Australian Resources Development Limited

Submission regarding AEMO's Draft 2022 Integrated System Plan

February 2022

Appendix 1: Impact of Renewable Energy on Electricity Consumers

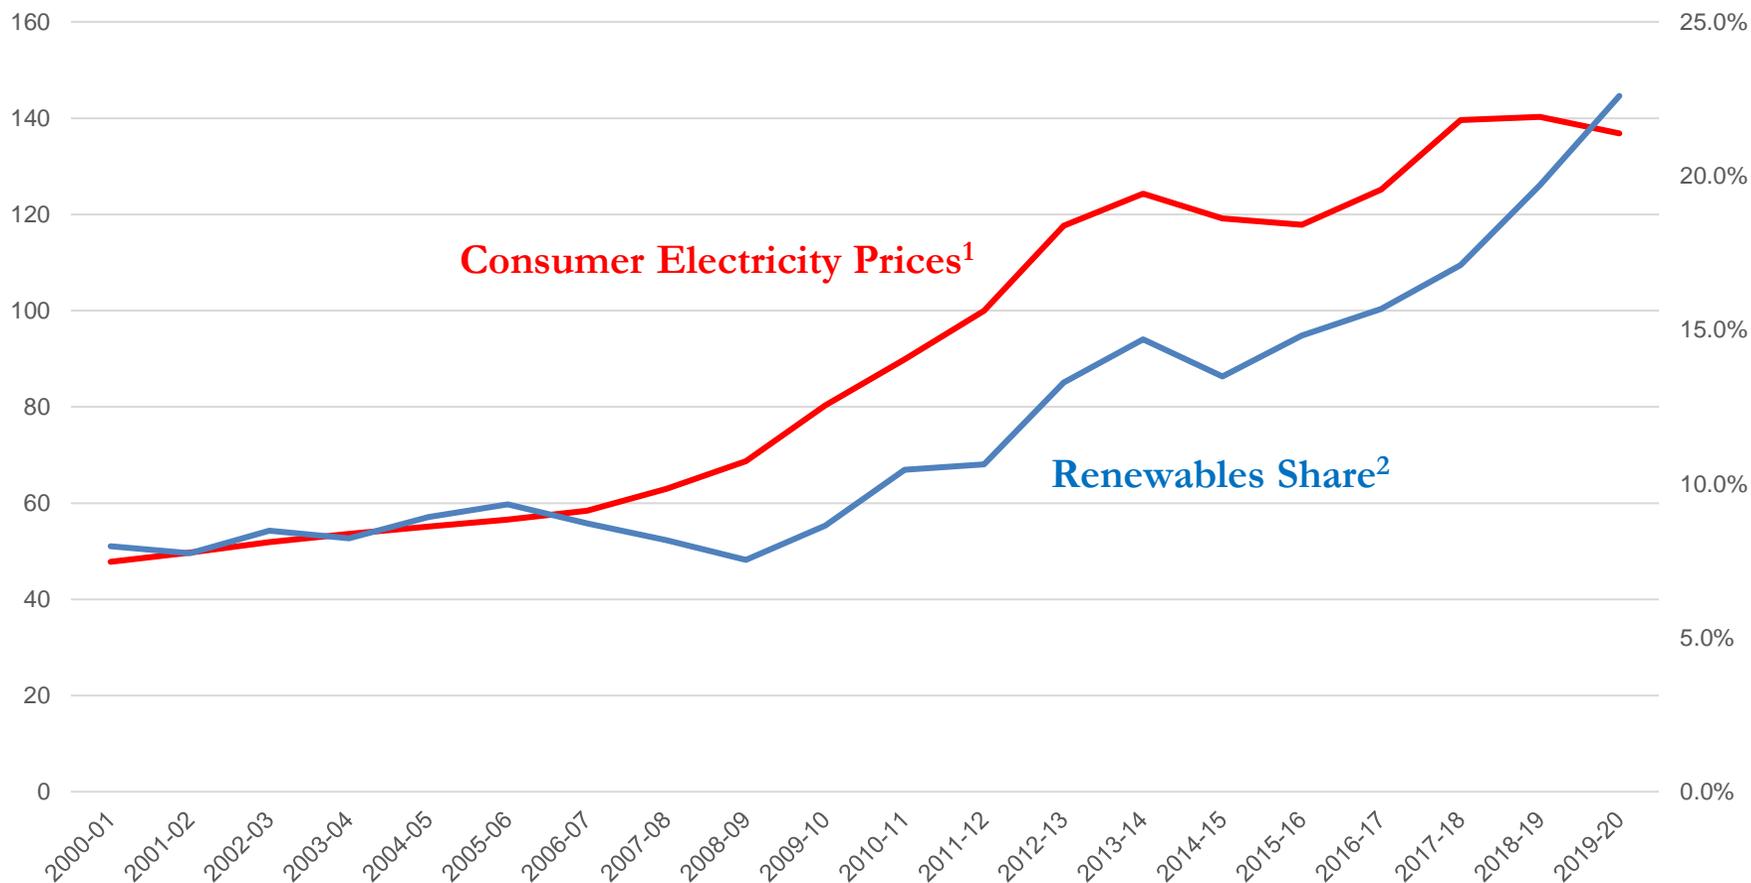
The Chart in Appendix 1 demonstrates graphically the massive increase in consumer electricity prices as a result of forcing the introduction of VRE into the NEM over recent years:

- ❑ This represents a significant transfer of wealth from power consumers (many of whom are in low-income brackets) to investors in renewable energy projects; i.e., the policies forcing the penetration of renewable energy are a regressive tax that differentially harms the low-income households and individuals.

Thus, the final 2022 ISP (**22FISP**) needs to explain the basis for the claim that that the NEM currently supplies “affordable” electricity.

Figure 21 A week's dispatch outcomes across the NEM (excluding Queensland), Step Change, 2039

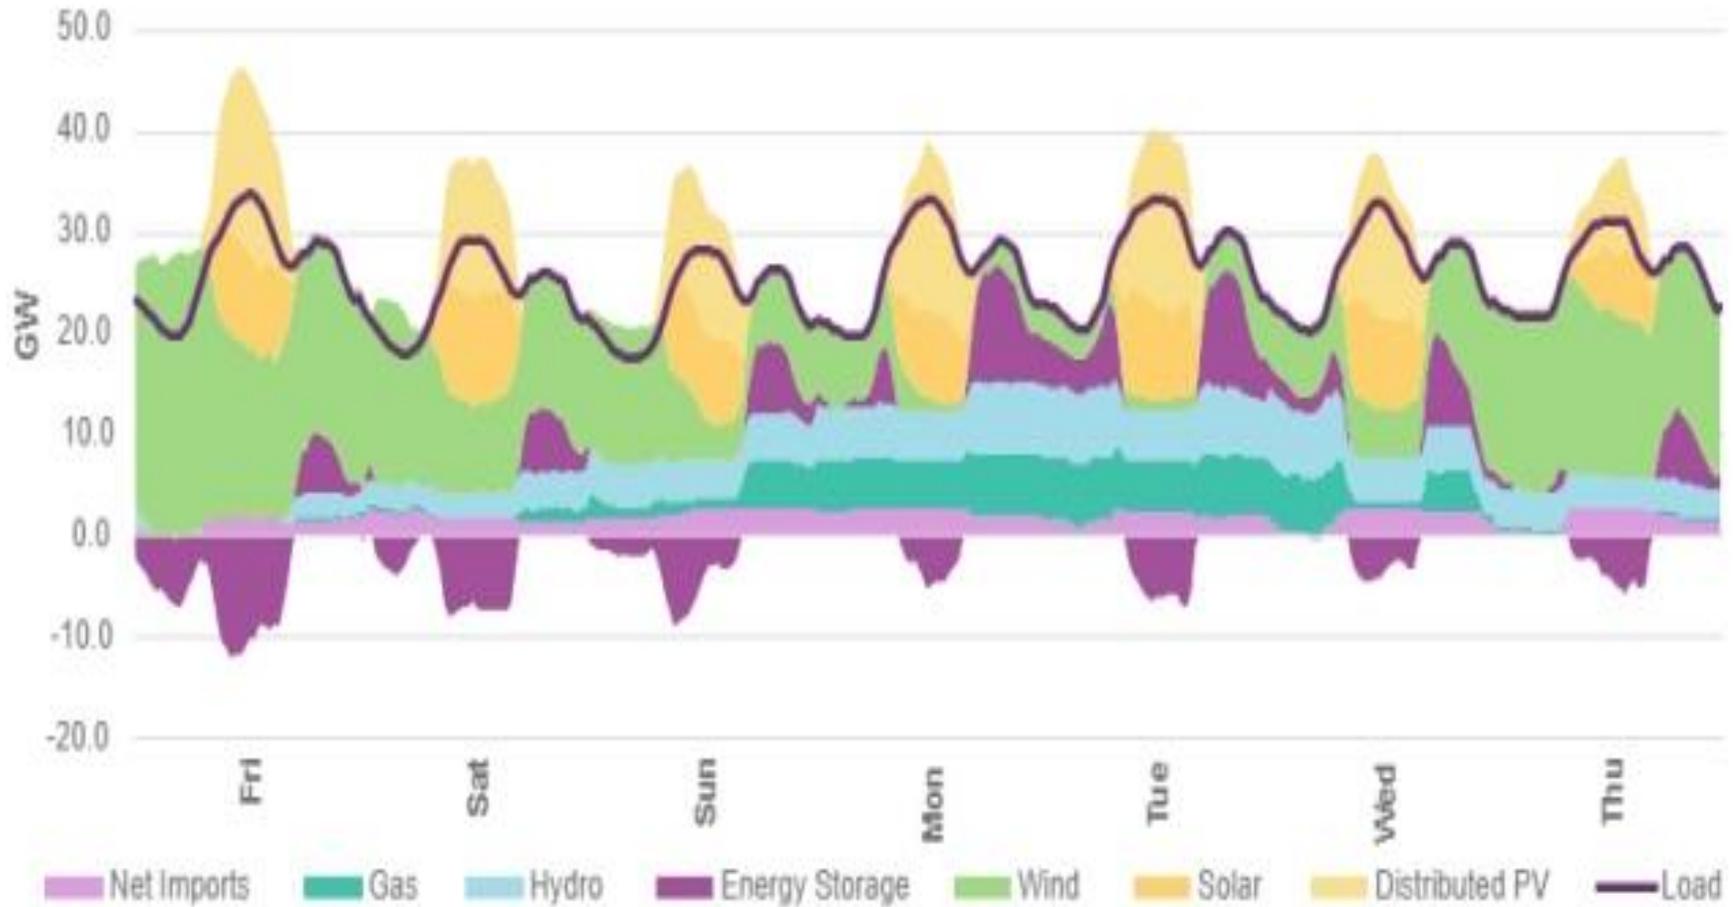
- Figure 21 (page 48, reproduced in Appendix 2) depicts such an outcome based on a “sample” winter week. VRE supplies approximately 70% of the electricity with the remainder from Firming Capacity (including gas and hydro). Significantly, the maximum rate of energy storage (**Storage Load**) is approximately 30% of the total load.

Thus, the final 22FISP needs to demonstrate in detail the robustness and credibility of its method of modelling the amount of Firming Capacity required to achieve the real-time balancing of supply and demand in a system where VRE supplies almost 100% of the generation:

Figure 37. Example time series of electricity supply and demand in Pathway 2 showing role of battery storage; NSW, 2046, 3 example days

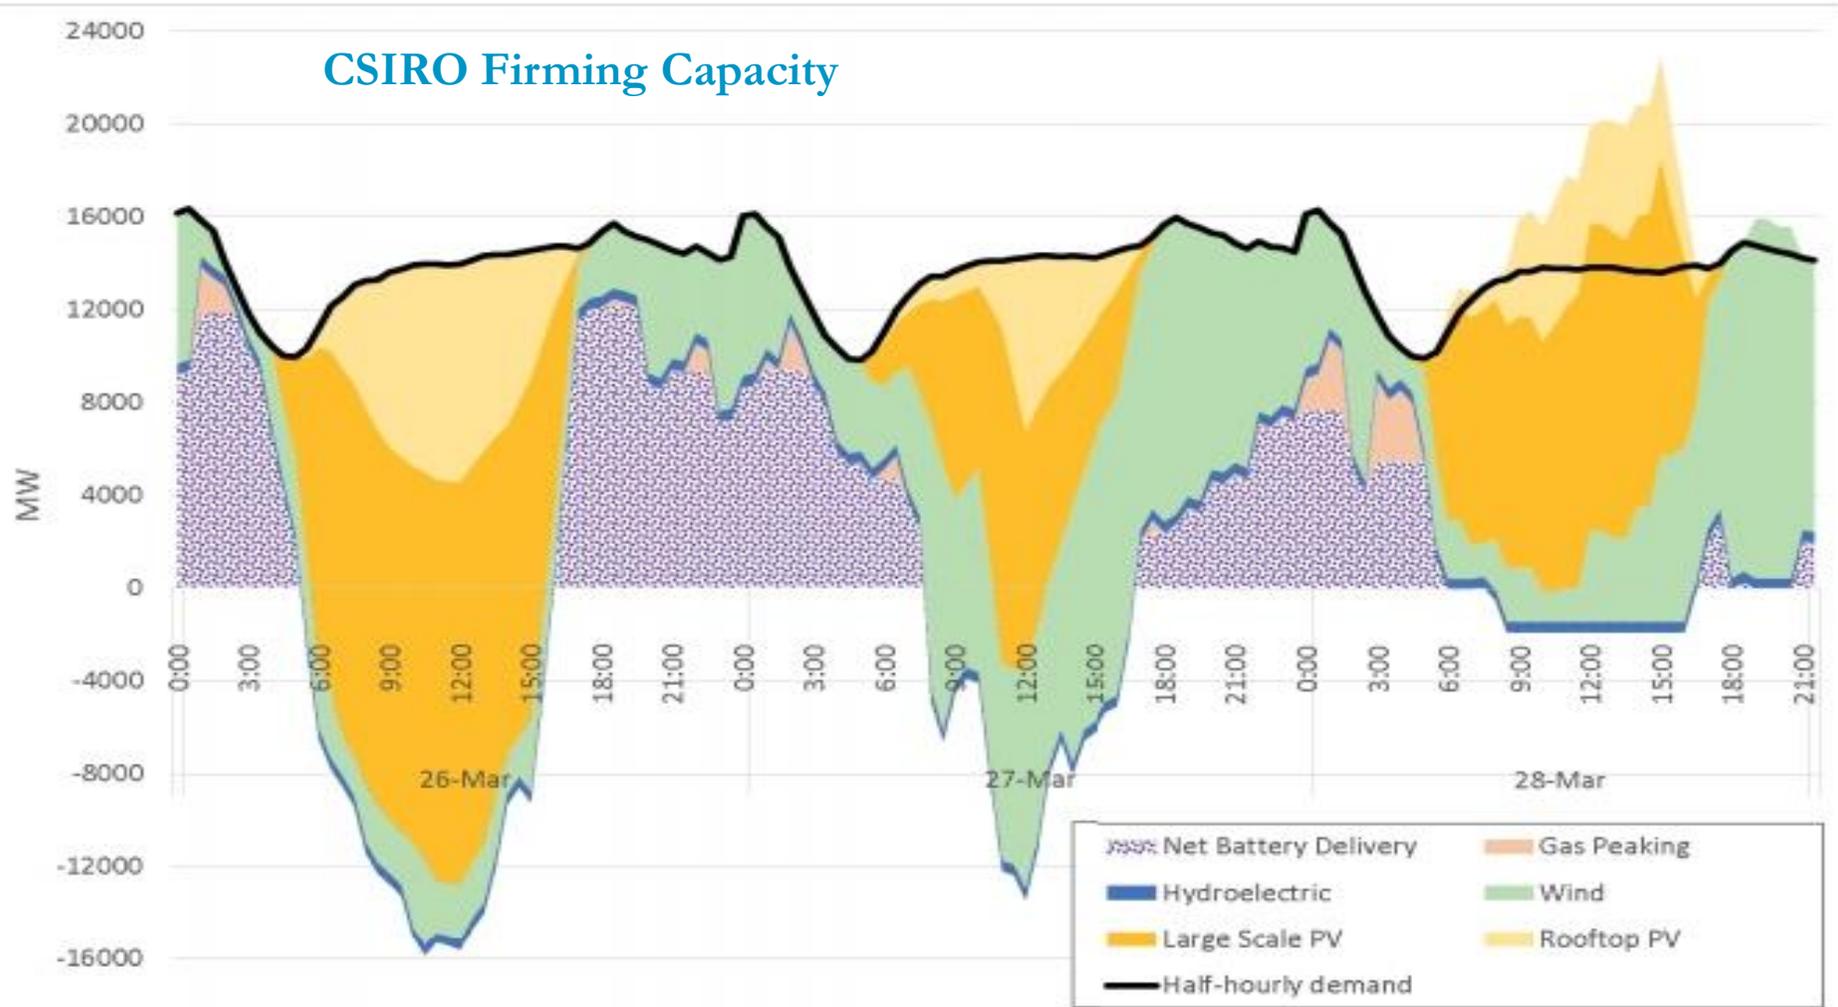
Figure 37 of the CSIRO Roadmap (page 115, reproduced in Appendix 2) depicts the Firming Capacity required to support VRE through three consecutive high battery use days in NSW; i.e., three days of low wind and sun. By observation, VRE supplies significantly less electricity than in the 22DISP “sample” week. Most significantly, the maximum Storage Load is approximately 120% of the total load which means that much more Firming Capacity must be installed to ensure a reliable supply, relative to the 22DISP Figure 21 profile:

- While the NEM regions are regularly subject to wind and solar droughts (**Weather Droughts**), the 22DISP only refers on the last page to these phenomena as “ ... possibly resulting in extremely low energy availability.” (Page 98); i.e., 22DISP fails to take account of Weather Droughts.

To date, Weather Droughts have had a minor impact on NEM supply reliability because coal-fired generators supply the majority of the load. The 22DISP’s failure to take account of Weather Droughts in sizing the amount of Firming Capacity to achieve the real-time balancing of supply and demand in a system where VRE supplies almost 100% of the generation casts serious doubt on the robustness of the 22DISP.

- To do this, the 22FISP will need to demonstrate clearly in the “ ... compound extreme event case studies ...” (Page 98) that the modelling faithfully takes account of the impact of the regular Weather Droughts experienced in the NEM regions.

Figure 11. Ratio of battery and VRE generation capacity (GW) required to achieve energy balancing for modelled shares of energy (GWh) delivered by VRE

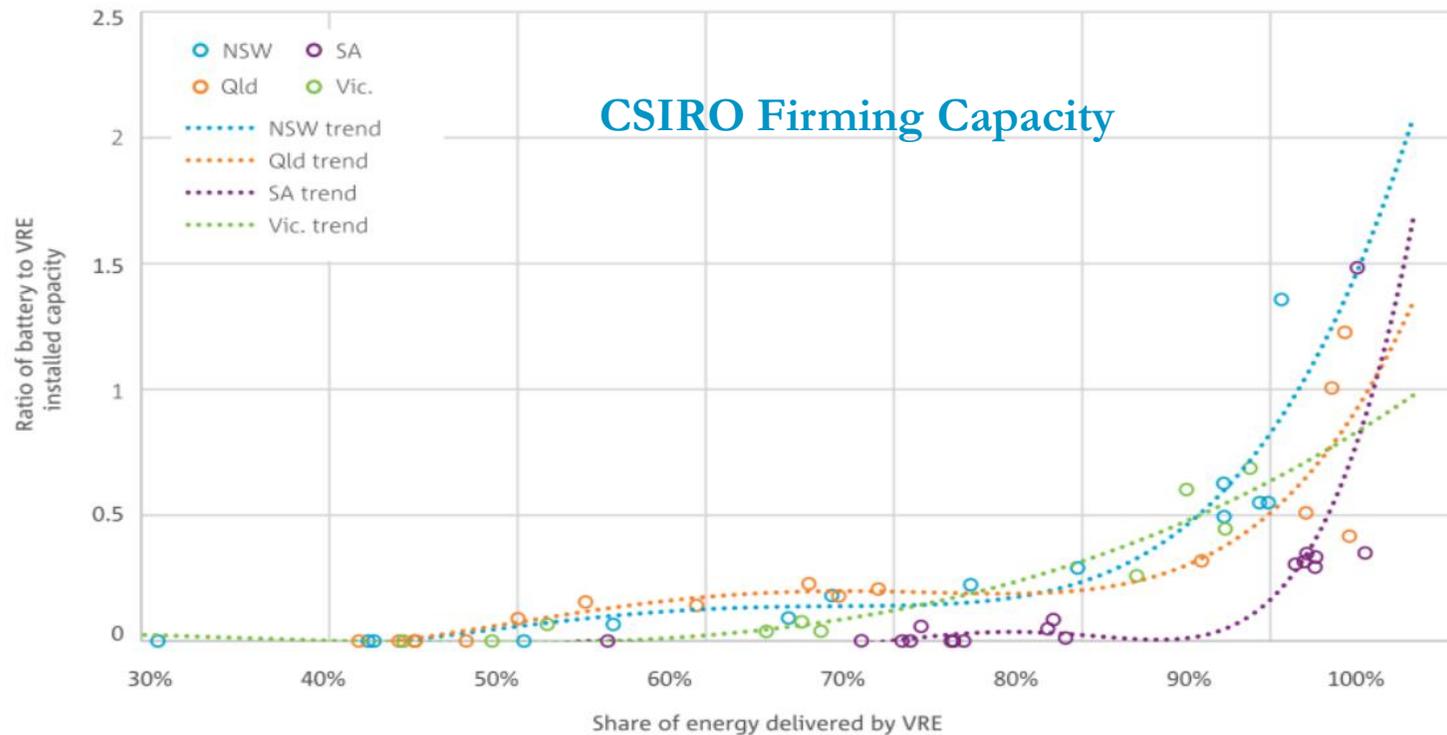
In this regard, Appendix 2 also reproduces Figure 11 of the CSIRO Roadmap which depicts the relationship between the VRE Ratio and the ratio of Firming Capacity to VRE generation capacity installed in the NEM regions (**FC Ratio**) which increases exponentially as the VRE Ratio increases:

Table 2 sets out the forecasts for the 22DISP FC Ratio based on the Step Change scenario forecasts and the CSIRO FC Ratio required for a reliable system based on Figure 11 of the CSIRO Modelling. There is clearly an enormous difference in determining the required Firming Capacity based on the 22DISP’s “sample” week and the CSIRO’s robust approach of using the “worst three week” period:

- The Figure demonstrates that as the VRE Ratio increases, the FC Ratio increases exponentially to ensure a reliable supply of electricity.
